Bray to City Centre Core Bus Corridor Scheme

NTA Observations on the Proposed Scheme Submissions

May 2024

Figure 3.22: Extract from Proposed Surface Water Drainage Works Drawings (Sheet 08)

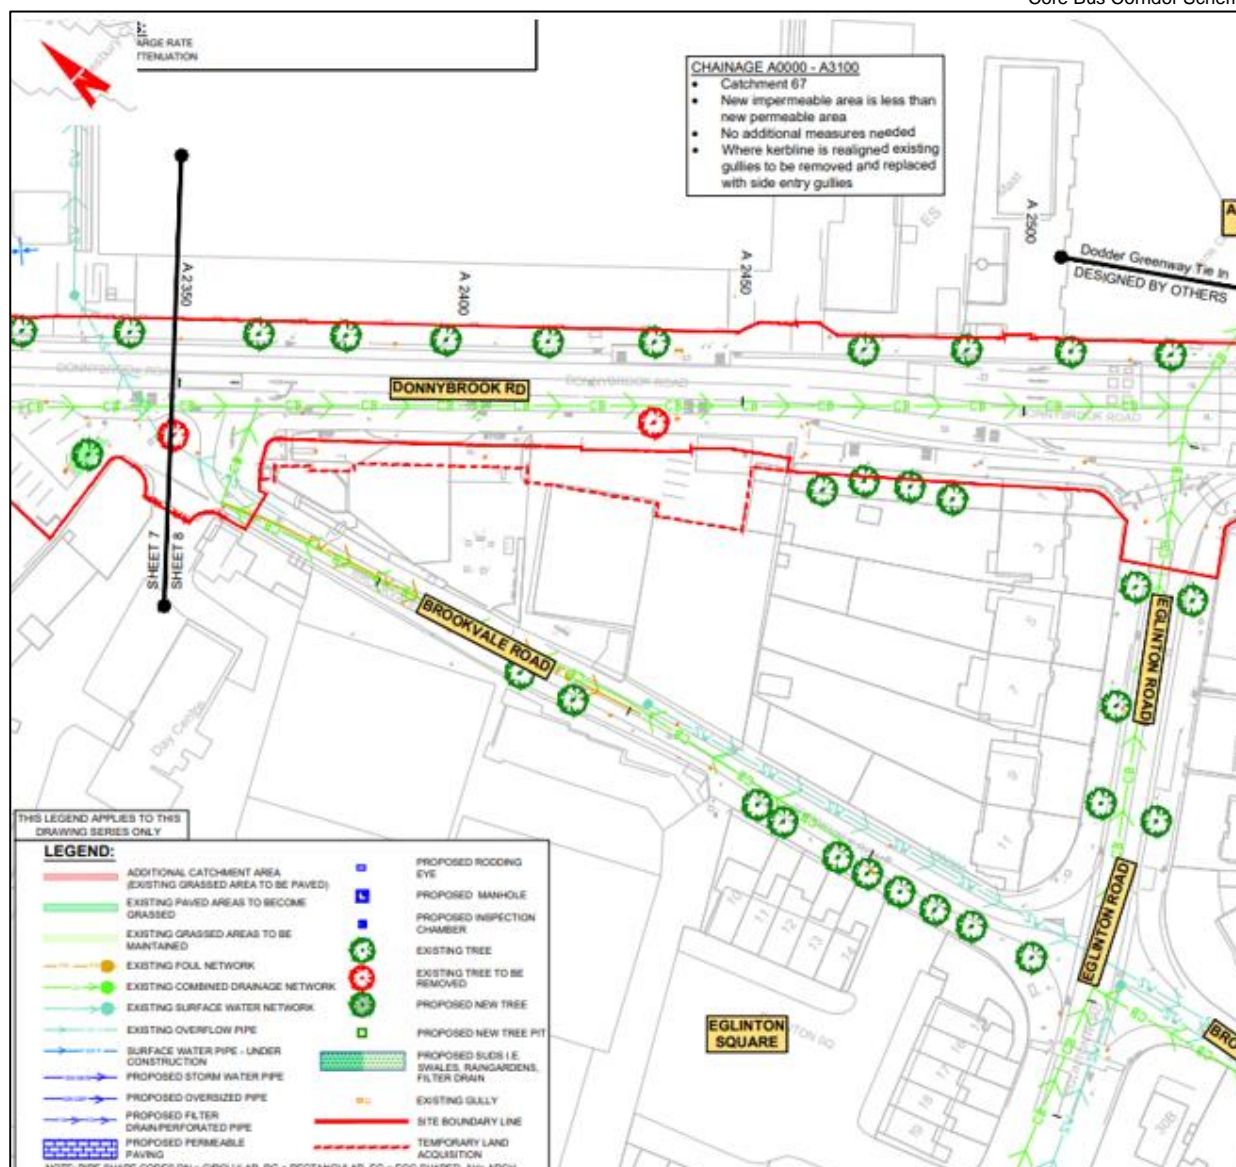
A Flood Risk Assessment was undertaken for the Proposed Scheme and is included as Appendix A13.2 in Volume 4 Part 3 of 4 of the EIAR. Supplementary information is also provided in Appendix K Drainage Design Basis Document of the Preliminary Design Report. The Proposed Surface Water Drainage works are presented in the 11-Proposed Surface Water Drainage Works drawings Sheet 08 in Chapter 4 (Proposed Scheme Description) in Volume 3, Part 2 of 3 of the EIAR and shown below in Figure 3.22.

Figure 3.26: Extract of General Arrangement Drawings at First Stop in Donnybrook (Sheet 08)

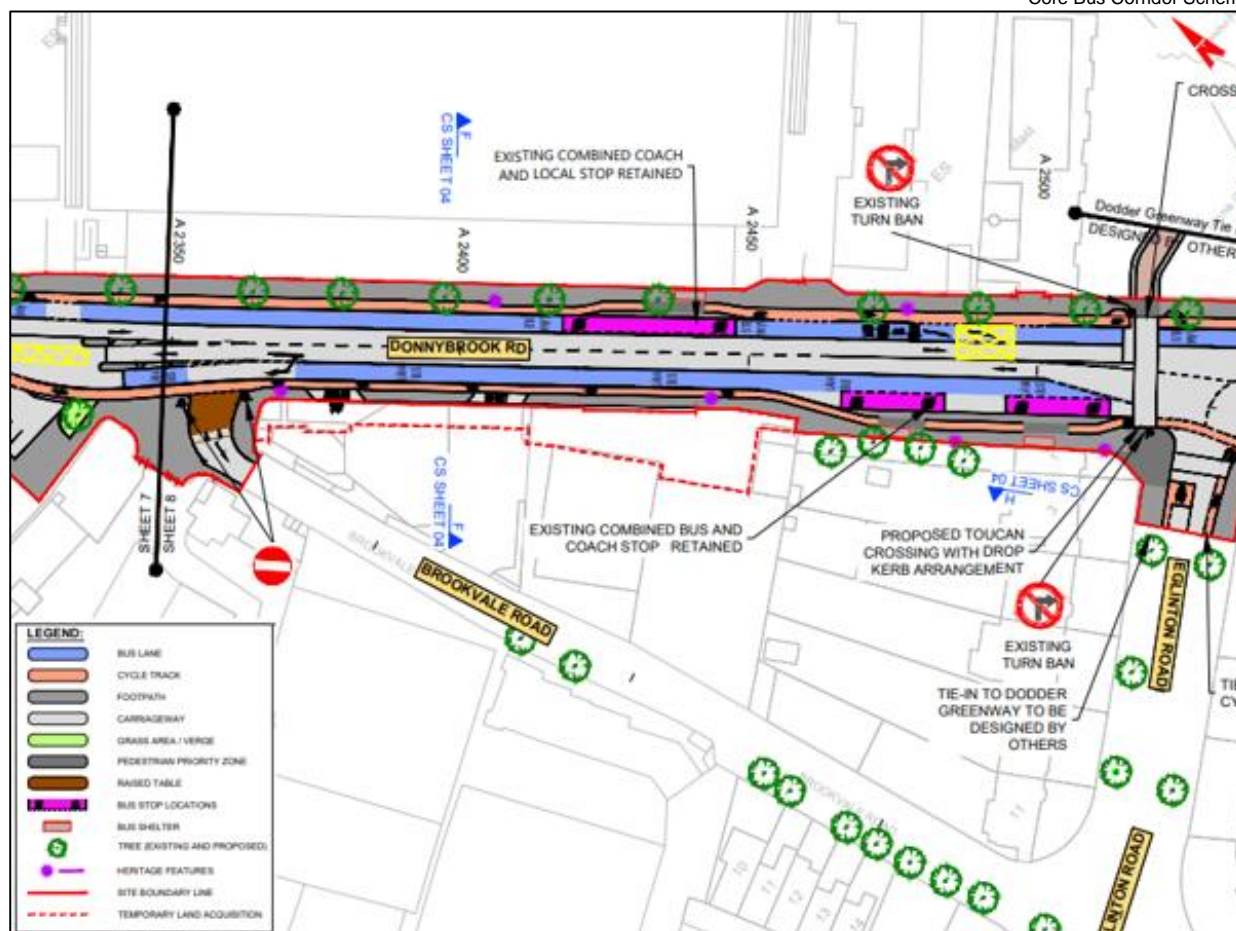
At the First Stop in Donnybrook, the cross-section proposed will include footpaths, segregated cycle tracks, bus lanes and traffic lanes in both directions. The Proposed Scheme design at First Stop is presented in the 02-General Arrangement Drawings Sheet 08 in Chapter 4 (Proposed Scheme Description) in Volume 3, Part 1 of 3 of the EIAR and shown in Figure 3.26.

Figure 3.28: Extract from General Arrangement Drawings at Private Development (Sheet 08)

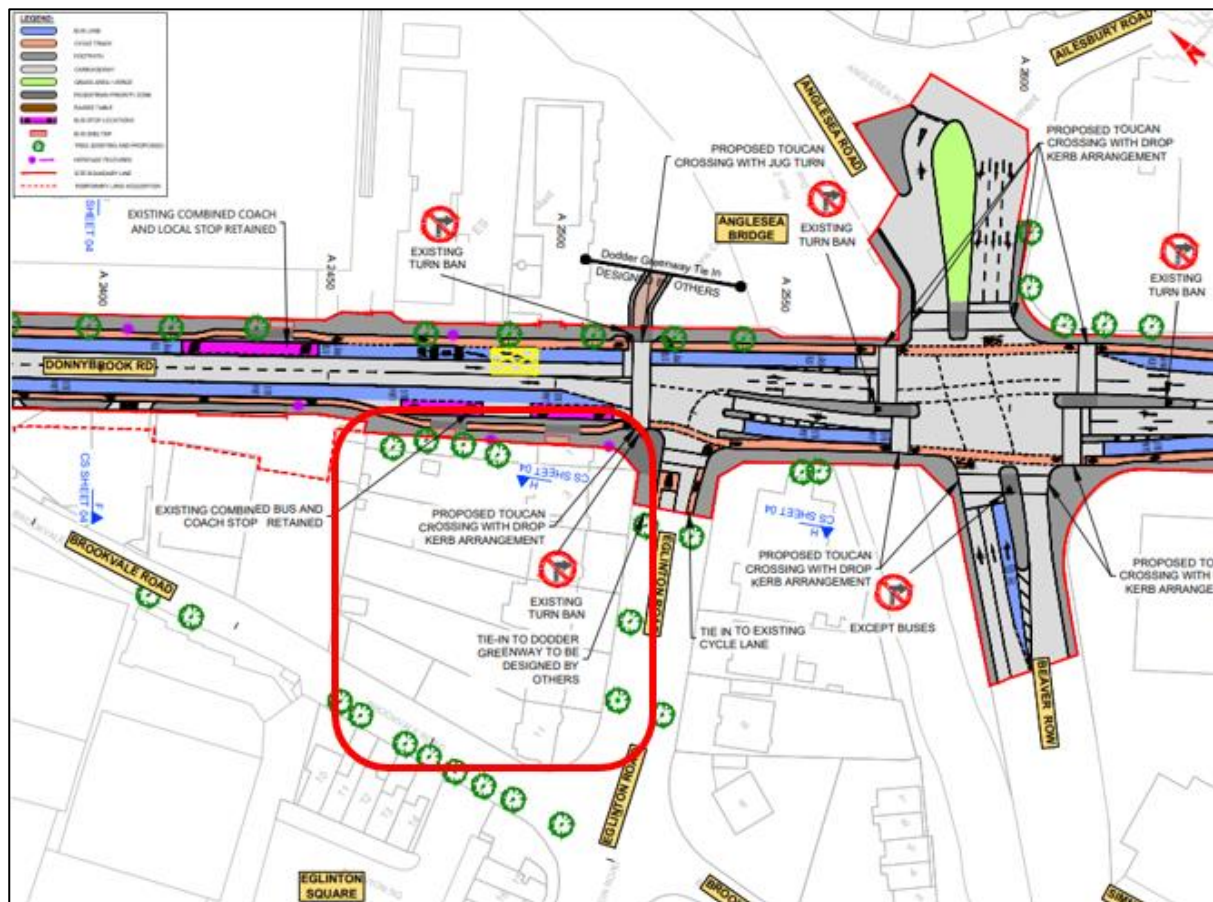
The Proposed Scheme design at the location of the private development on Eglinton Road is presented in the 02-General Arrangement Drawings Sheet 08 in Chapter 4 (Proposed Scheme Description) in Volume 3, Part 1 of 3 of the EIAR and shown in Figure 3.28.

Figure 3.36: Extract from Junction Design Report (Page 56 and 57)

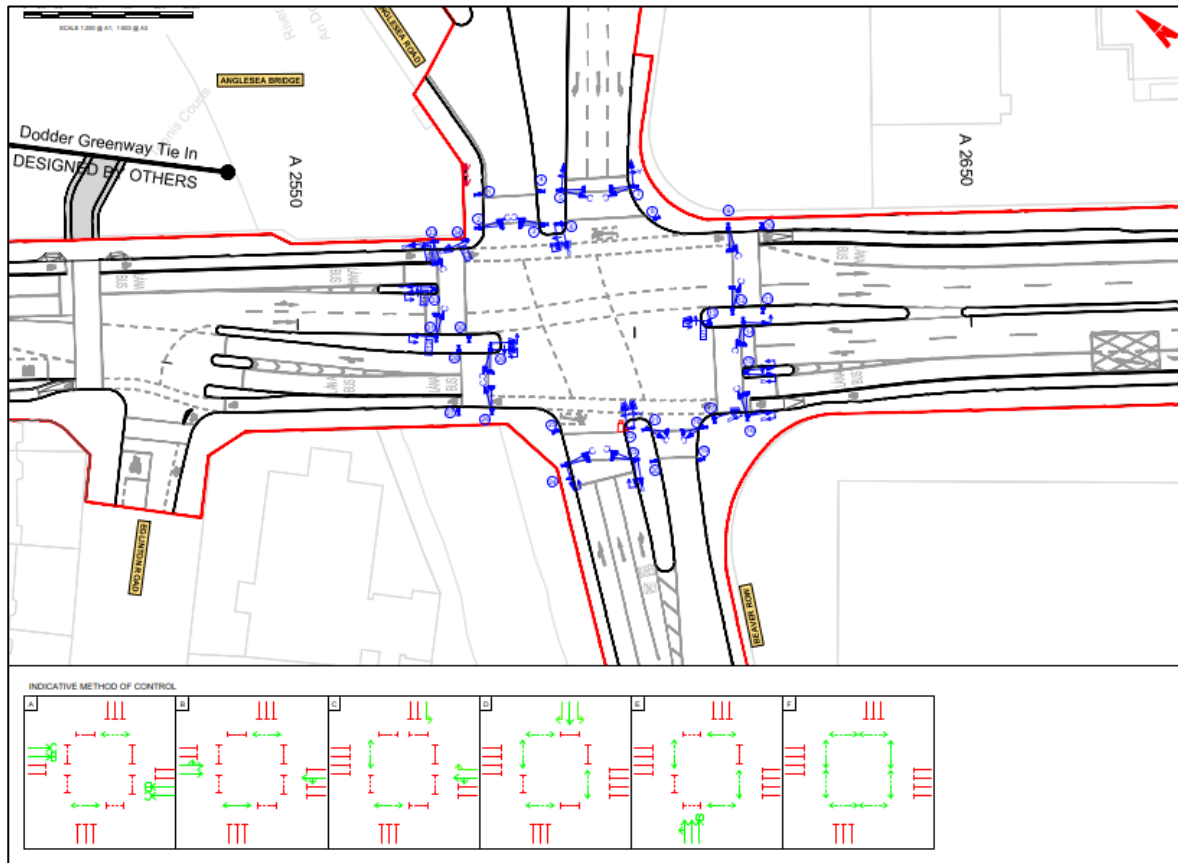
The signal phasing at the Beaver Row/ Anglesea Road / Donnybrook Road Junction is shown on page 56 and 57 of TIA Sub Appendix 2 - Junction Design Report Volume 4 Appendices Part 1 of 4 of the EIAR. A 6-stage traffic signal phasing is proposed at this junction and can be seen in the extract from page 56 and 57 of the Junction Design Report in Figure 3.36 below.

Figure 3.49: Extract from General Arrangement Drawings at Coláiste Eoin (Sheet 16)

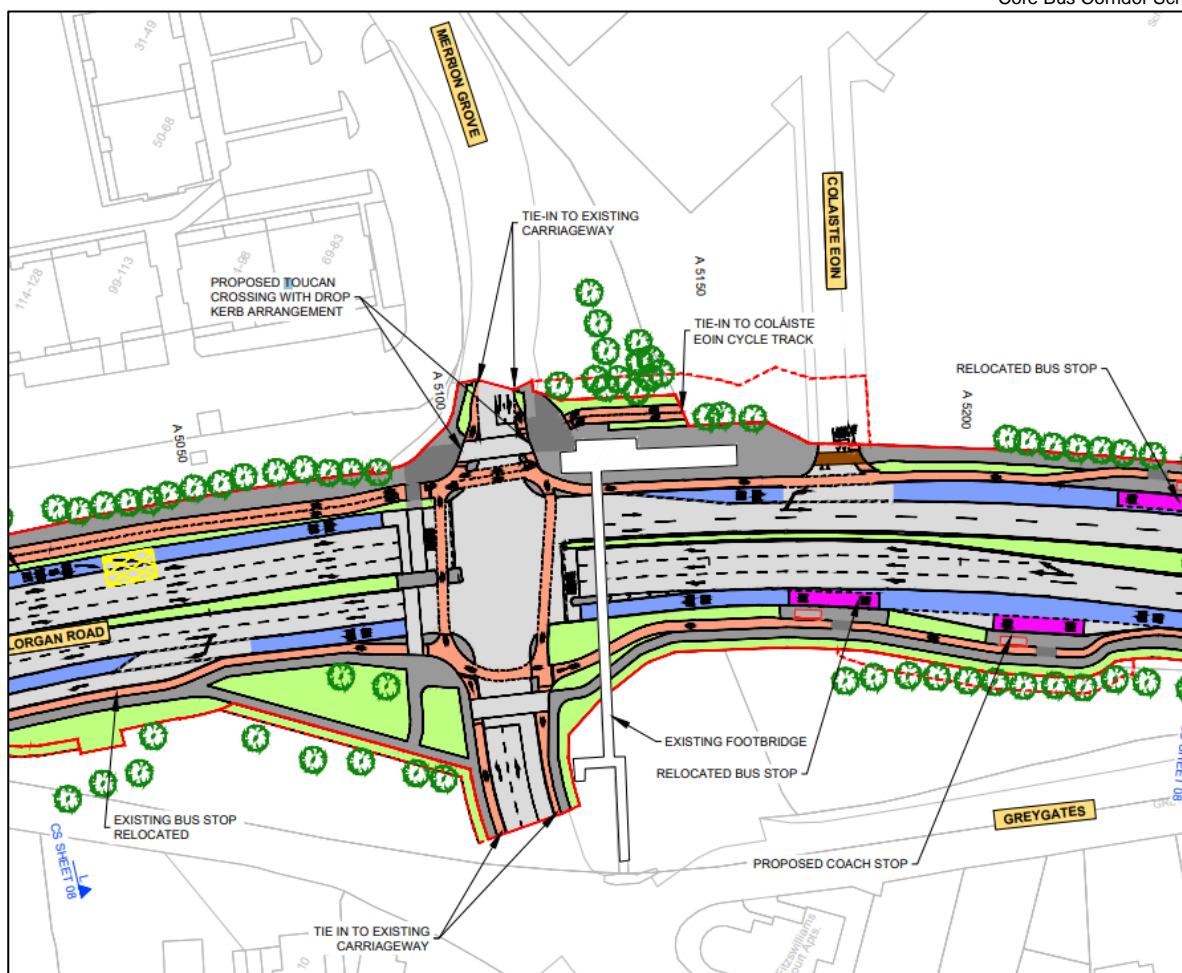
The Proposed Scheme design at the location of Coláiste Eoin and Coláiste Íosagáin school are presented in 02-General Arrangement Drawings Sheet 16 in Chapter 4 (Proposed Scheme Description) in Volume 3, Part 1 of 3 of the EIAR and shown in Figure 3.49. As part of the BusConnects Bray to City Centre CBC works, permanent land take (a short strip shown in the CPO maps) is required to provide the two-way cycle track connection to the school.

Figure 3.60: Extract from Updated Draft PRO Drawings - Third round of non-statutory consultation (Map 22: Preferred Route)

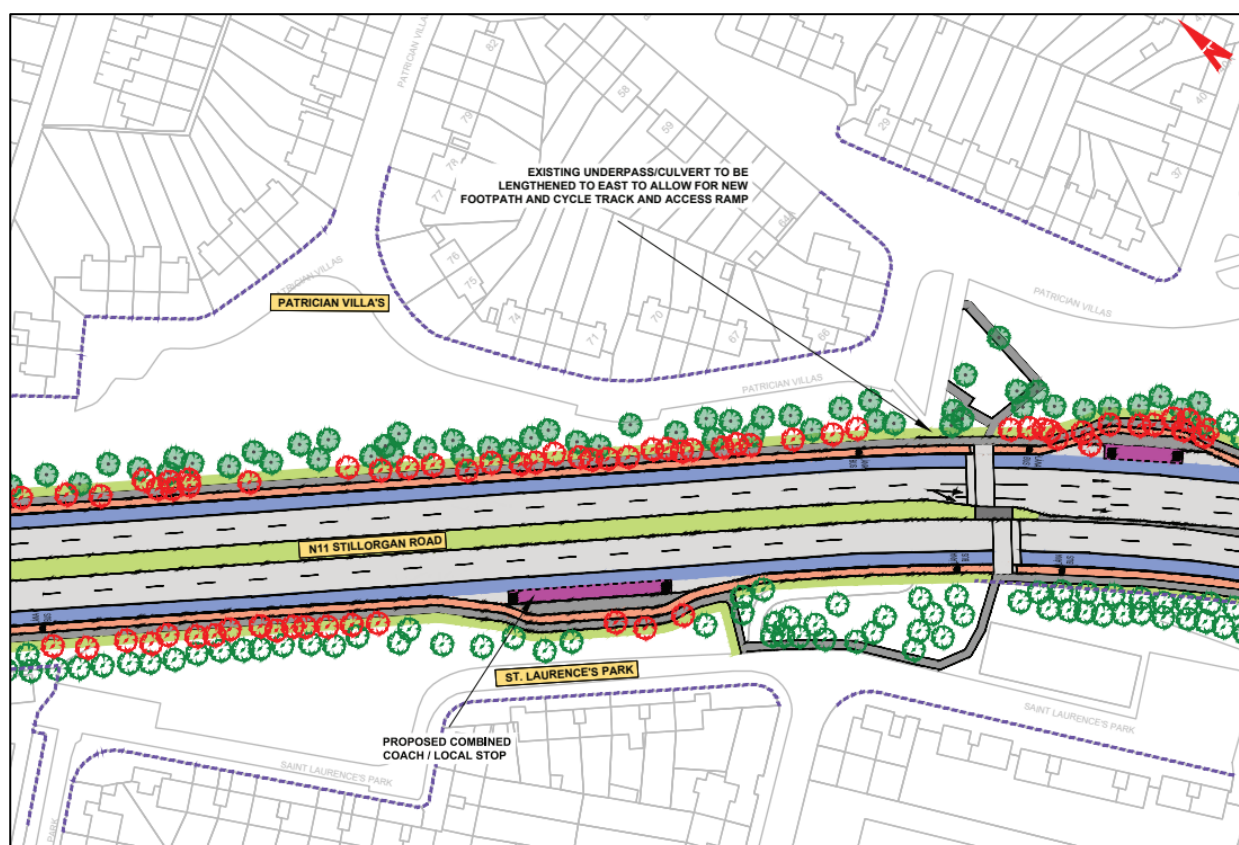
The Proposed Scheme drawings in the consultation brochure highlighted a slightly revised arrangement for the proposal to lengthen the existing underpass/culvert to facilitate the proposed new footpath at Patrician Villas, as well as a slightly revised signalised crossing of the N11, see Figure 3.60 below.
